RE: U.S. Patent Application Serial No. 09/889,759  
Our ref: WOLFRAMM ET AL-1

APPLICANT: ARIBERT WOLFRAMM ET AL.-1 EXAMINER: S. BUCZINSKI  
SERIAL NO.: 09/889,759 GROUP: 3662  
FILED: JULY 20, 2001 CONFIRMATION NO. 1045  
FOR: METHOD FOR INTERFEROMETRIC RADAR MEASUREMENT

AMENDMENT IN RESPONSE TO THE FIRST OFFICE ACTION

Fig. 2

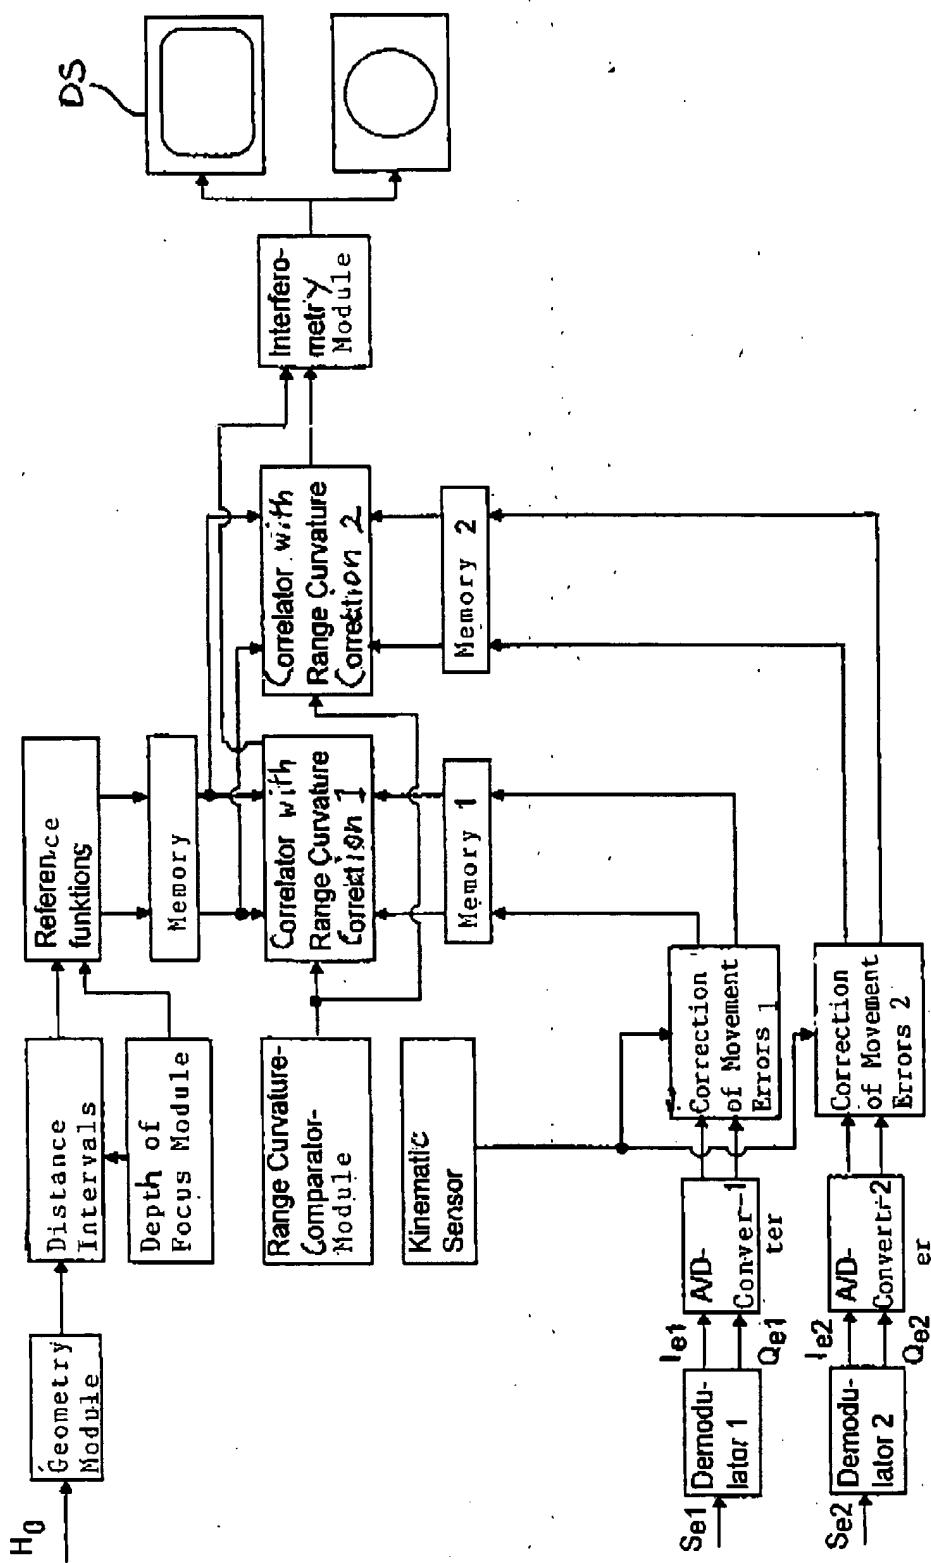
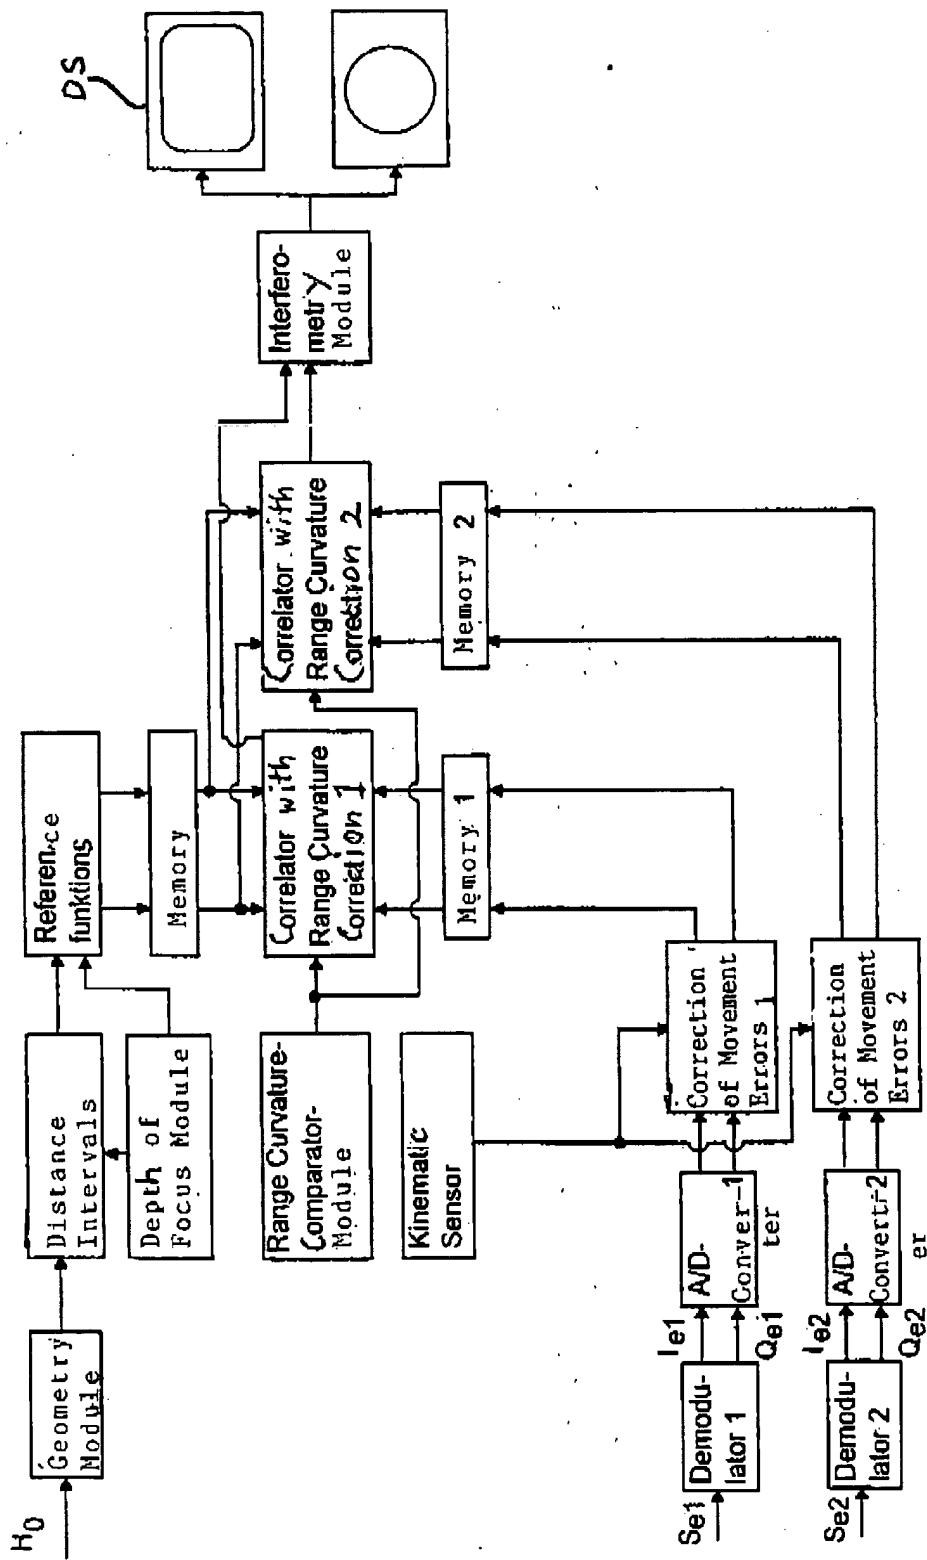
The Examiner has objected to the drawings. FIG. 2 has been amended to clearly label the display screen. Further, image points on a graphics display screen are commonly known to those in the field, and the applicant believes that they have been adequately shown in the drawing. Additionally, the image points on a graphics display screen are included in a dependent method claim and are not an element of the apparatus being claimed.

FIG. 2 has been amended. A marked-up copy and a substitute copy of FIG. 2 are enclosed (Attachment A).
